RTCA Special Committee 209

Mode S Transponder MOPS Maintenance

Meeting #3

**Detailing The Proposed Changes to Figures in
Order to Harmonize DO-181D and ED-73C**

Figure 2-16R2: WITH CHANGES PROPOSED TO HARMONIZE WITH ED-73C Figure 3-15 with SI Protocol

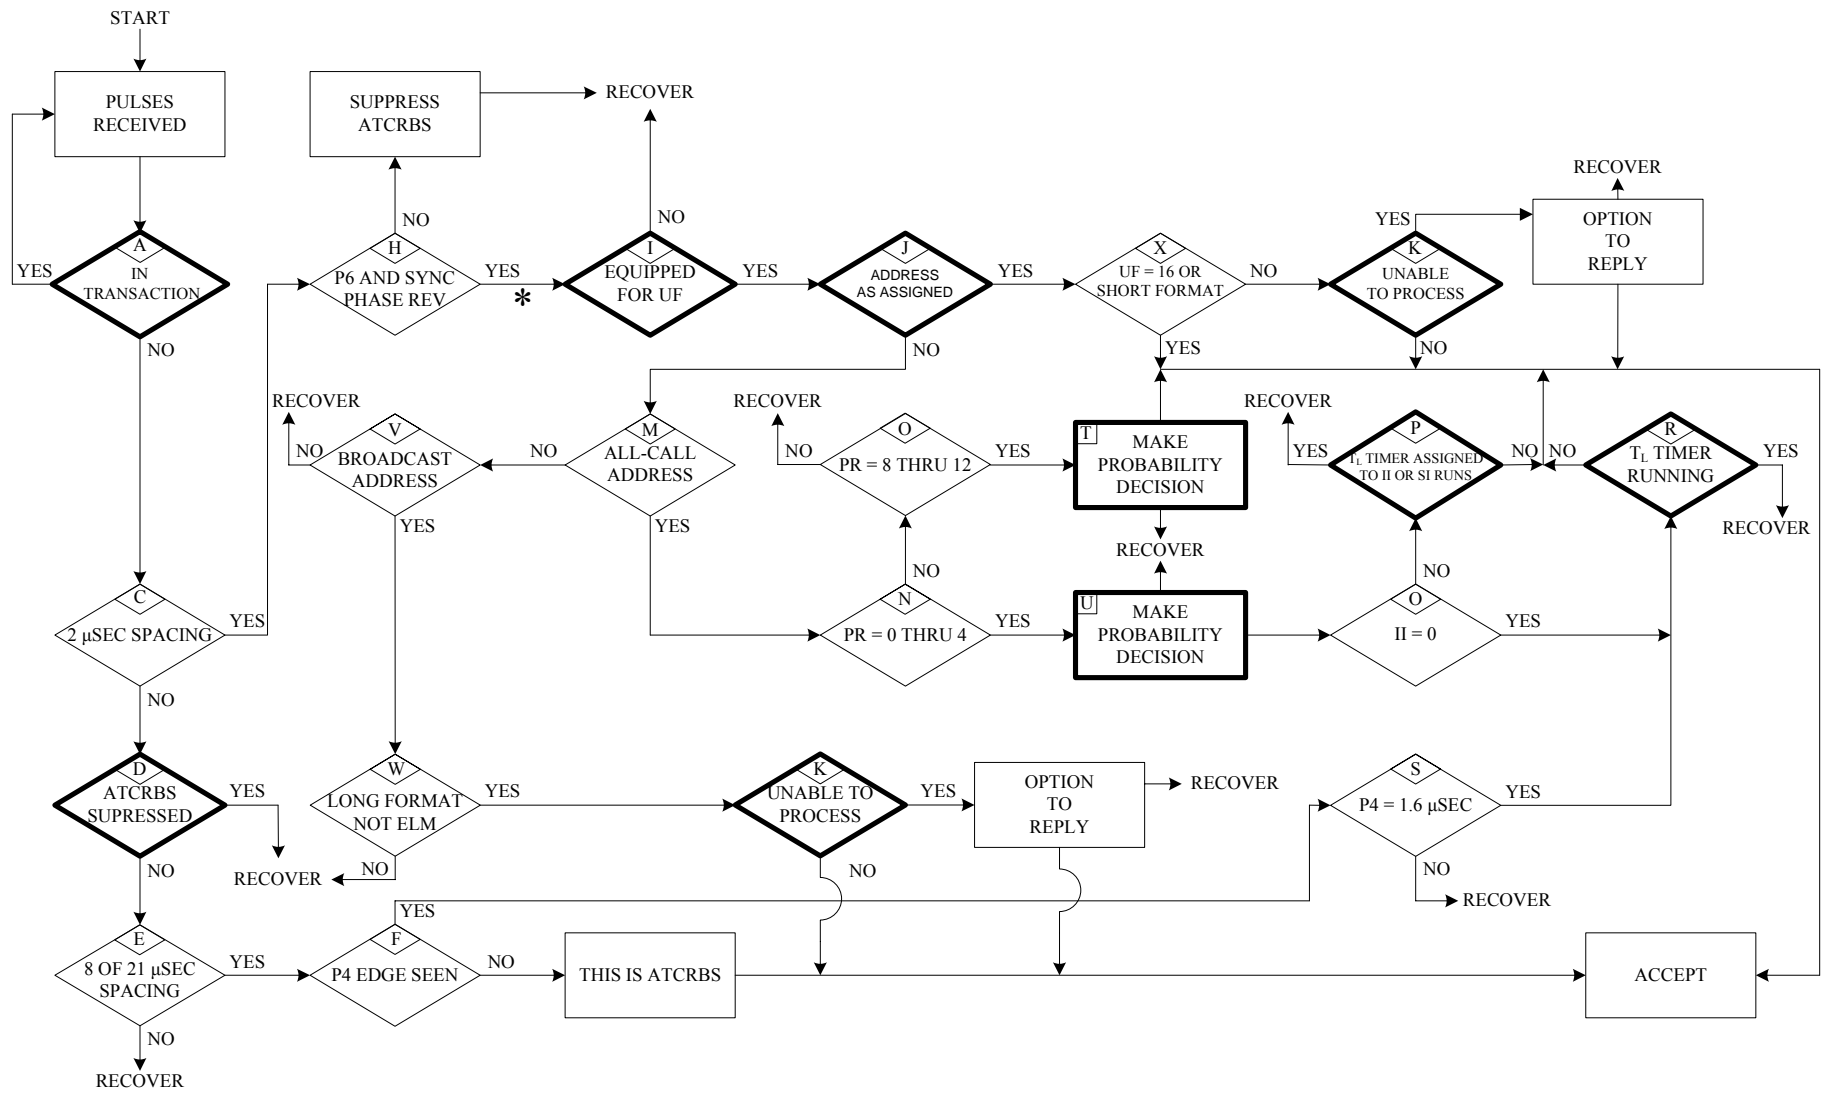
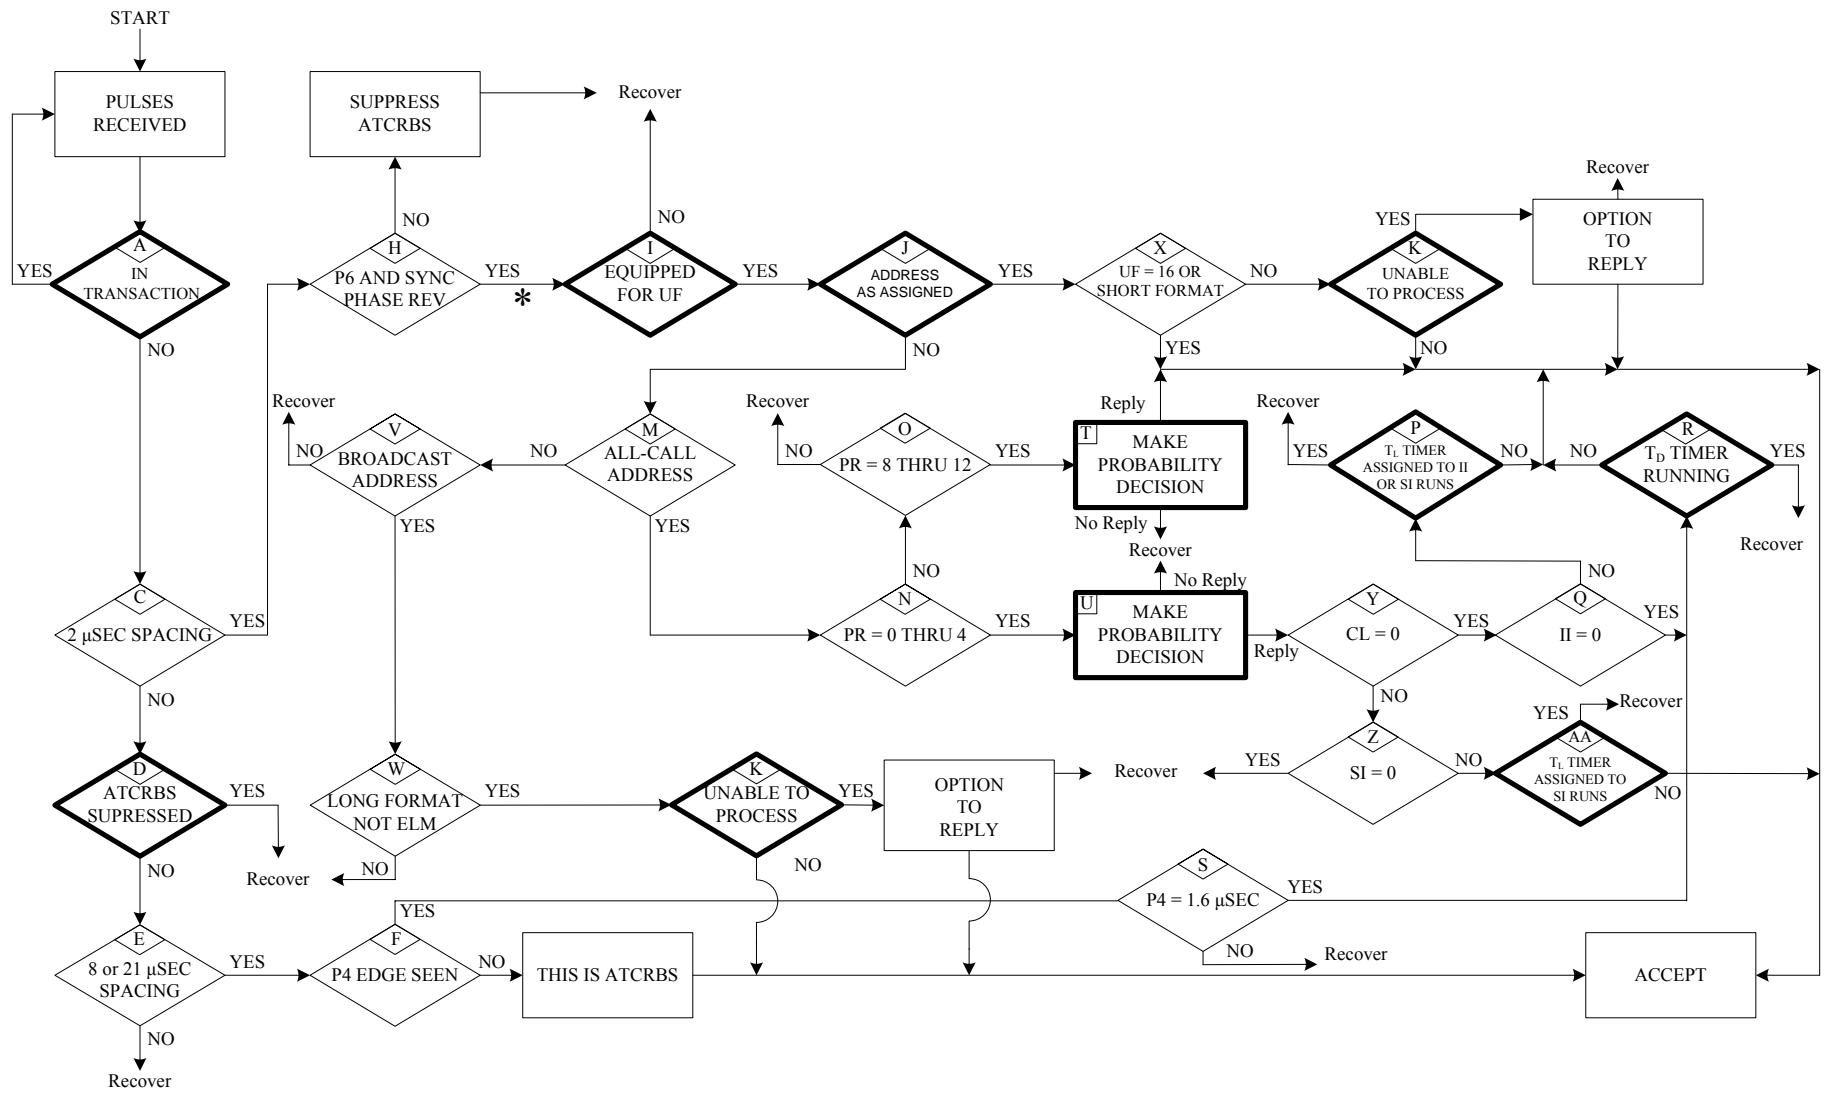
8. Figure 2-16 in DO-181D differed from Figure 3-15 in ED-73C because it appears that Figure 3-15 had been updated to add the decision boxes for SI protocol and Figure 2-16 had not been updated. Therefore Figure 2-16 is shown below as the original and Figure 2-16R2 is shown as modified to account for the addition of the blocks for SI protocol. Figure 2-16R1 was presented during the Brussels meeting showing two “Option to Reply” decision boxes added by Tom Pagano, and are retained in Figure 2-16R2 below.

Figure 2-23R1: WITH CHANGES PROPOSED TO HARMONIZE WITH ED-73C Figure 3-22

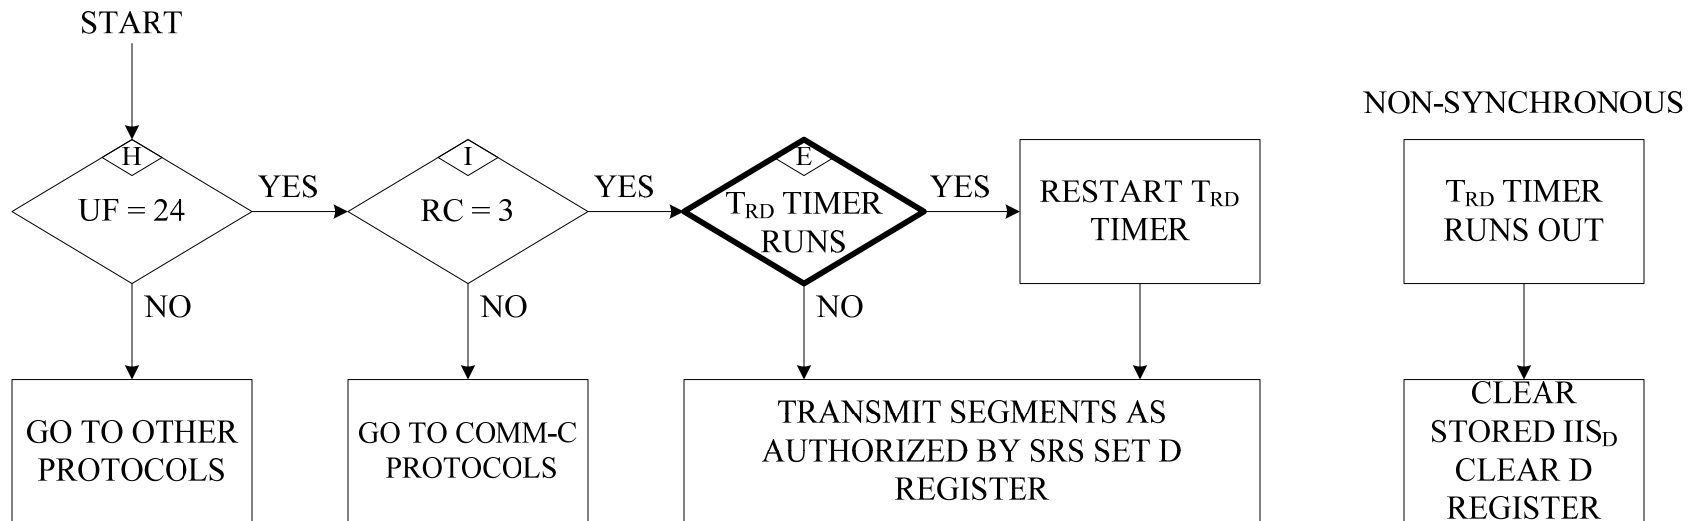
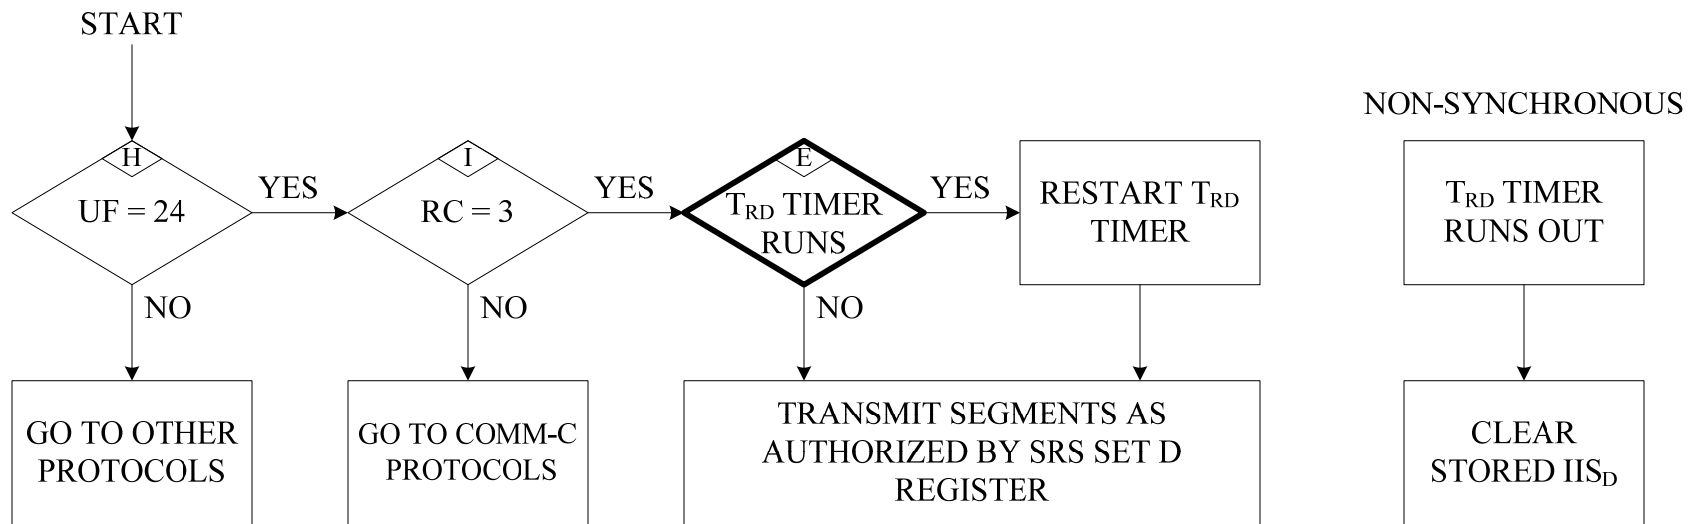
13. Figure 3-22 in ED-73C has an error in the outputs of decision box “E” where the “YES” and “NO” are reversed. This is correct in Figure 2-23 in DO-181D. However, there is another error in Figure 2-23 in that whenever the TRD Timer runs out, the “D” Register should NOT be cleared as in the bottom box under the “Non-Synchronous” boxes on the extreme right of the figure. The original Figure 2-23 and the proposed revised Figure 2-23R1 appear below.
